# Cleveland City Planning Commission

Friday, September 3, 2021

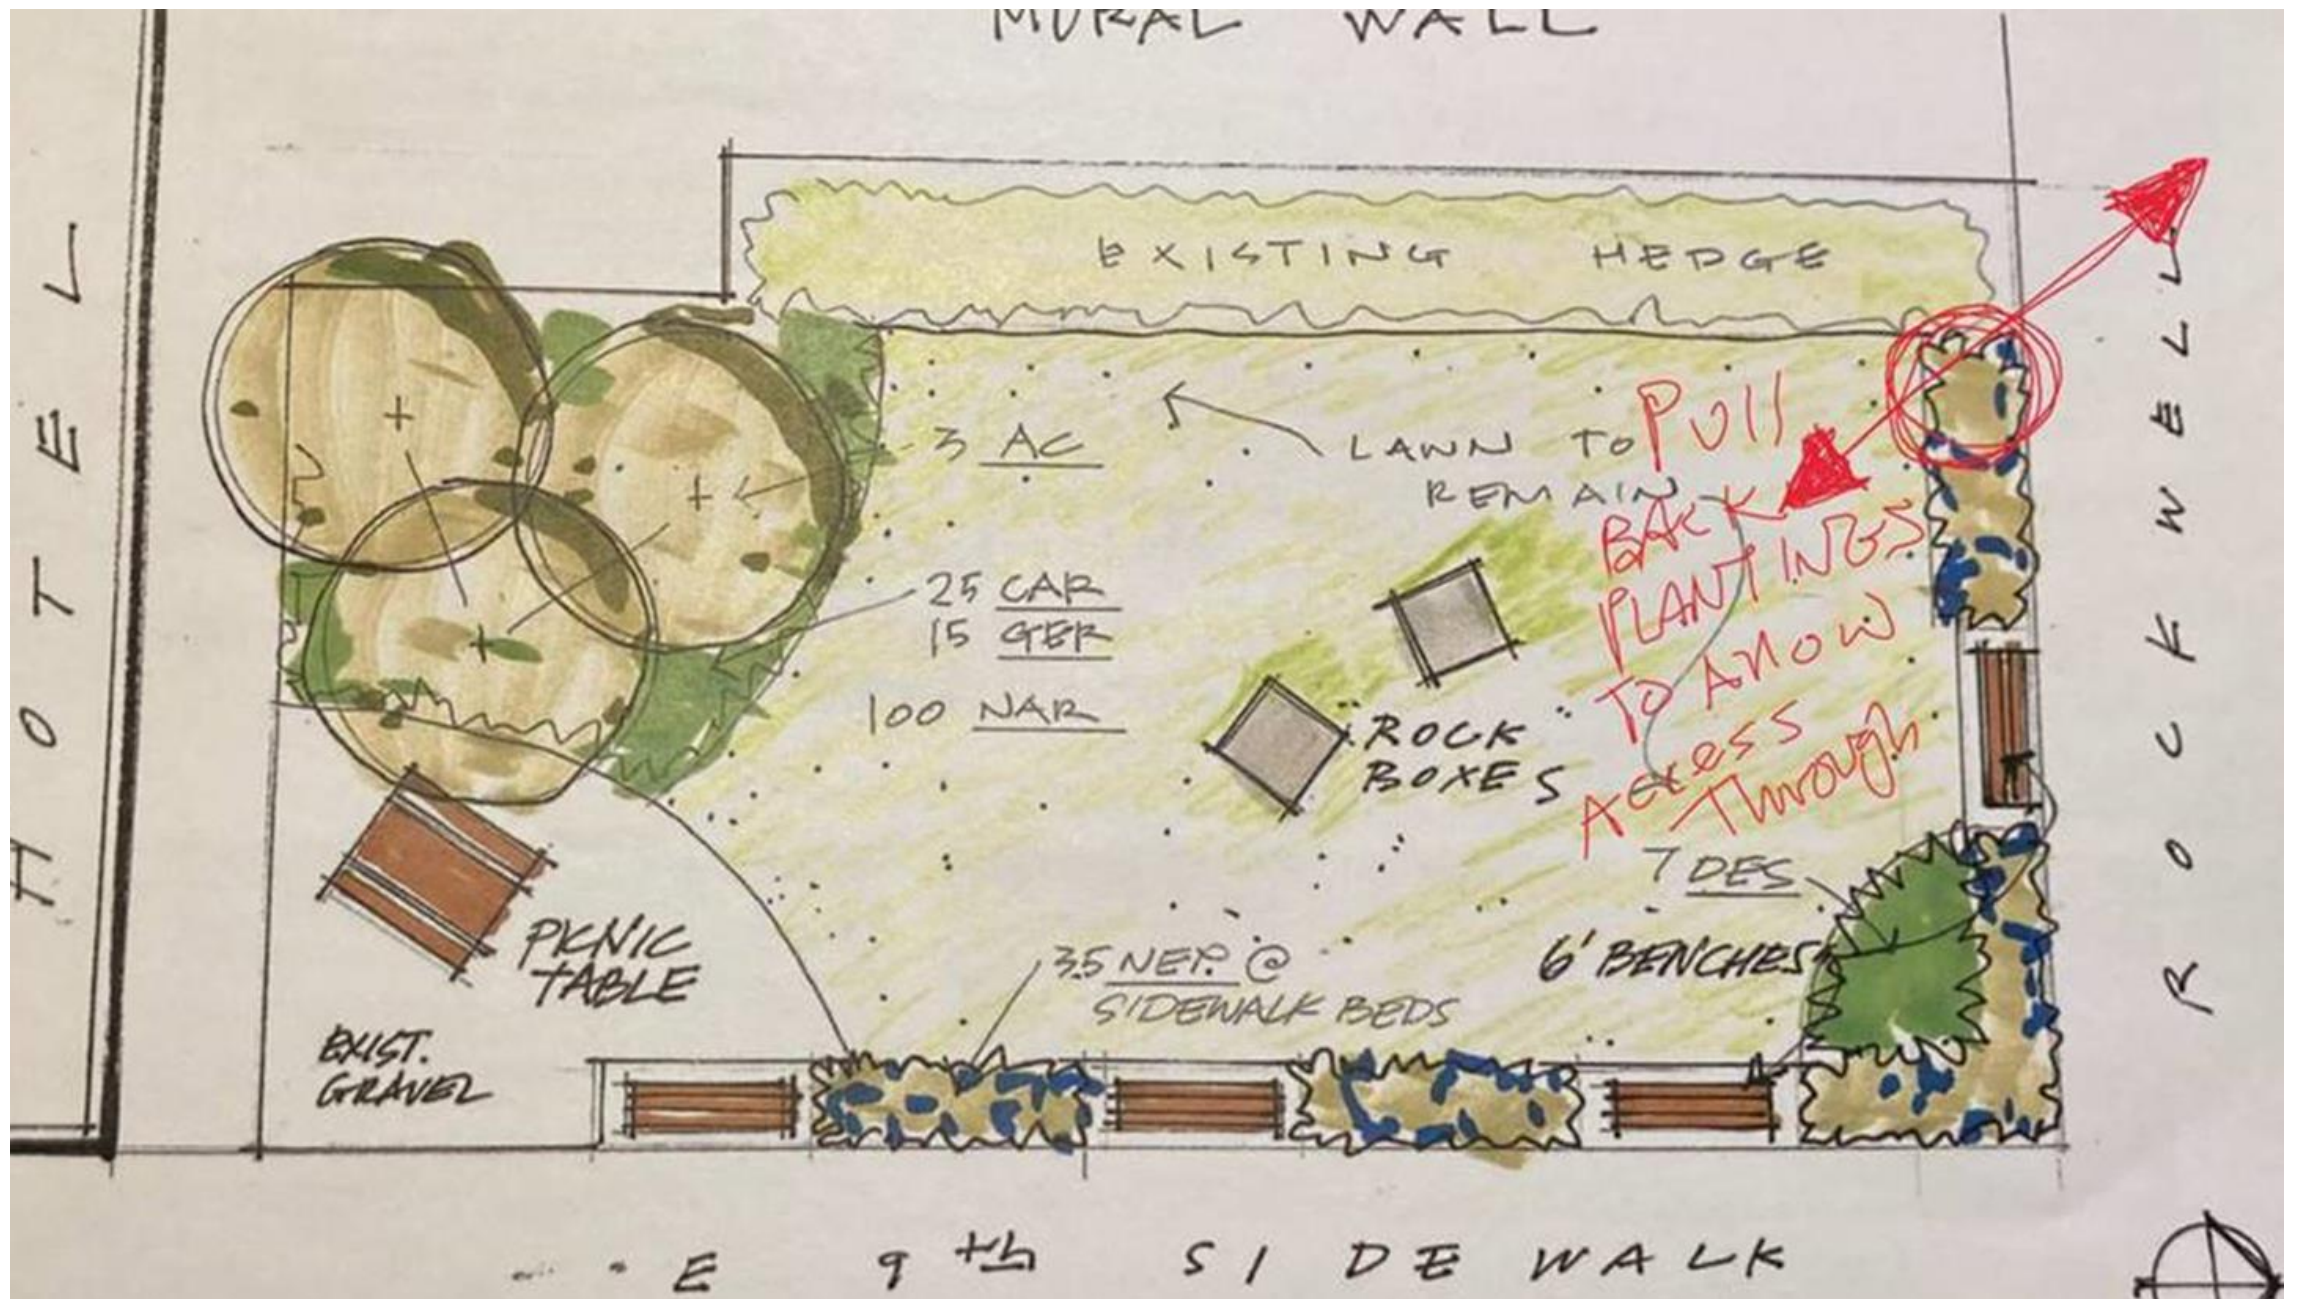
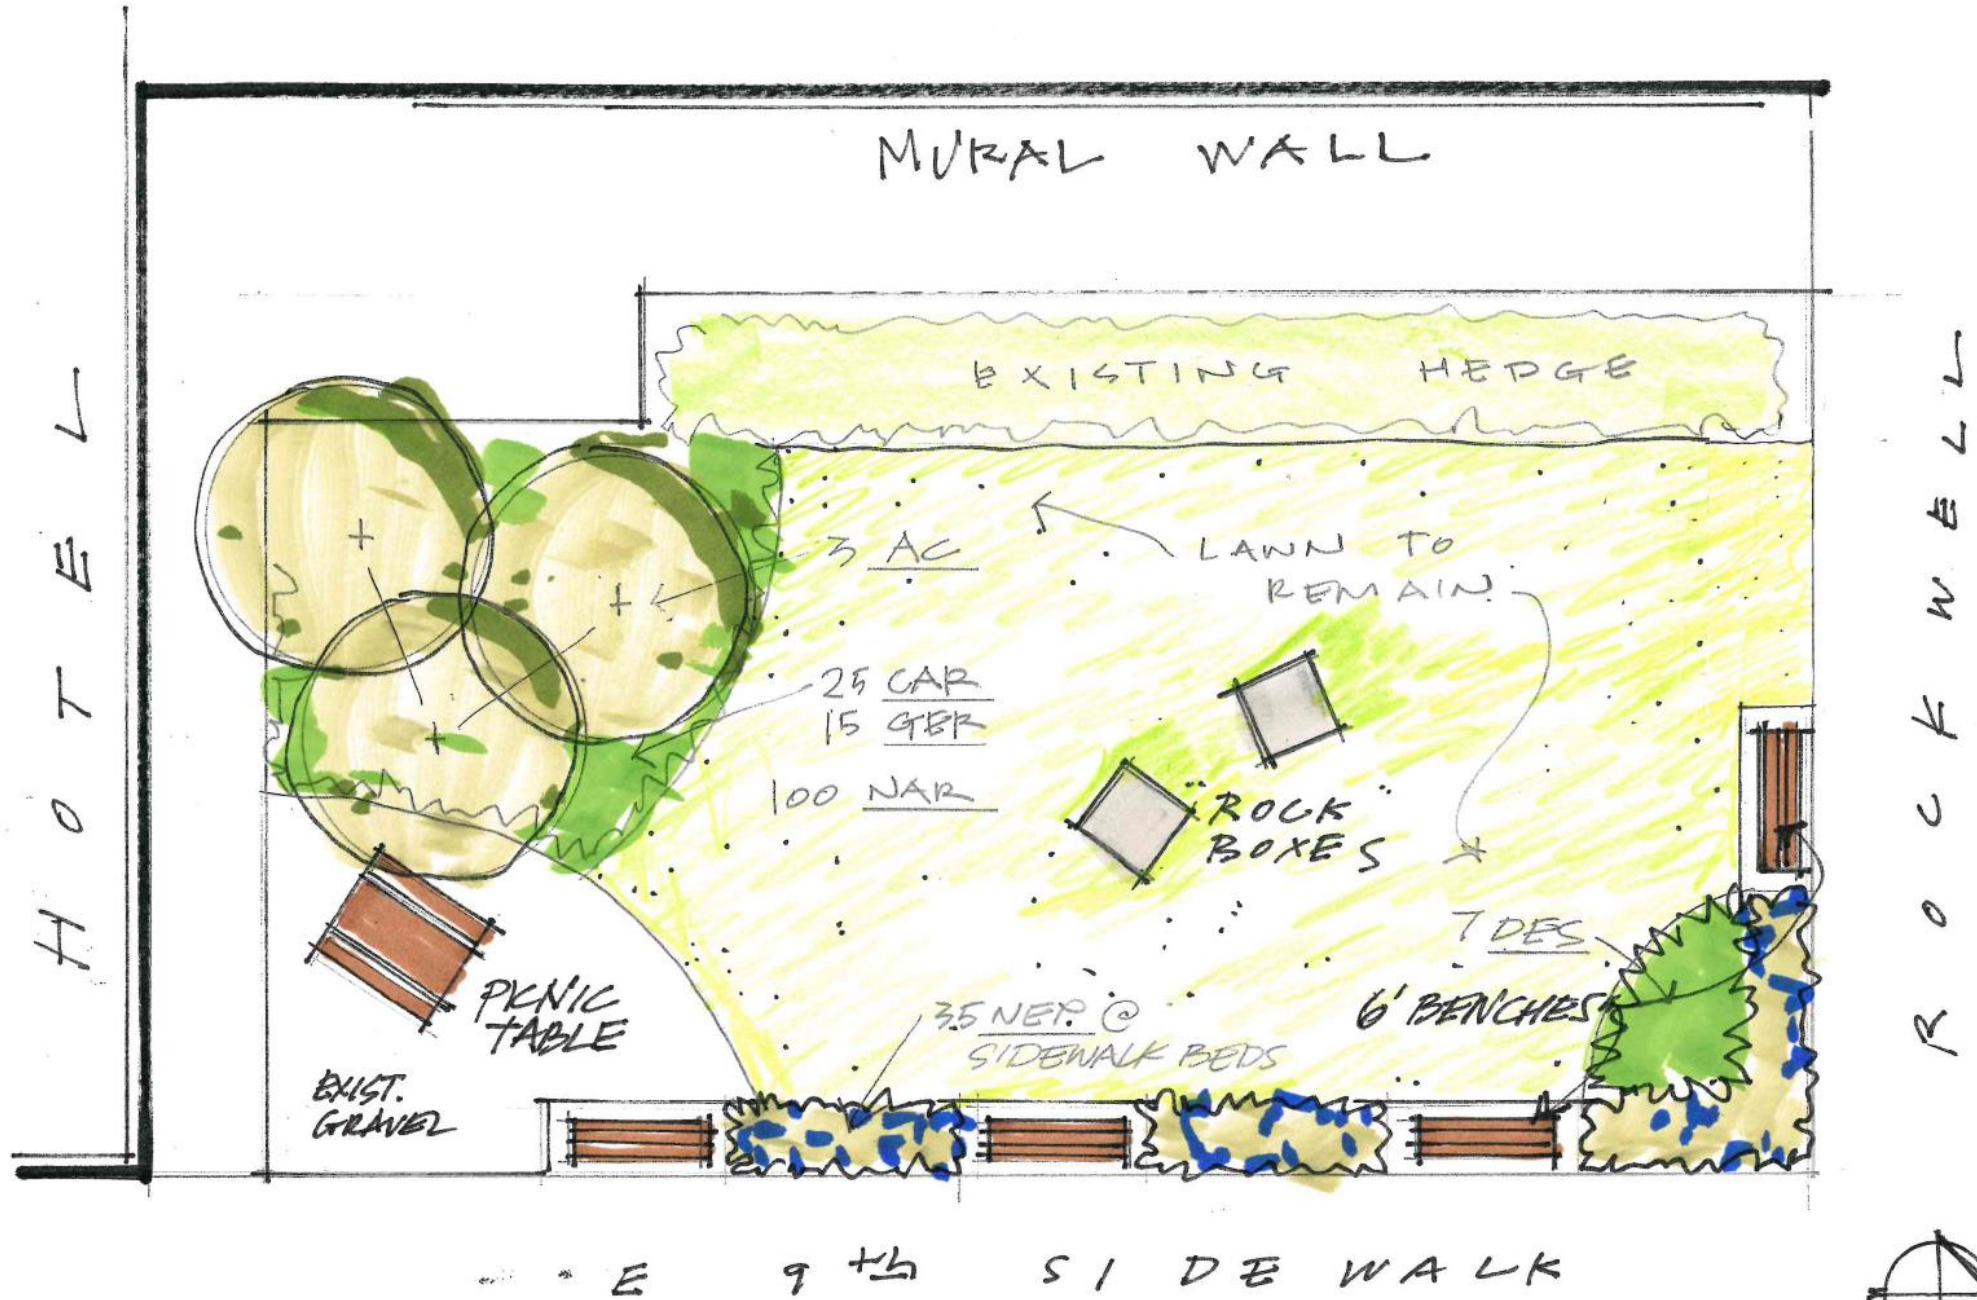
**Design Review Feedback: Improve Access – Create more than one point of entry/exit.**

**UPDATED DESIGN BASED ON DESIGN REVIEW FEEDBACK.**
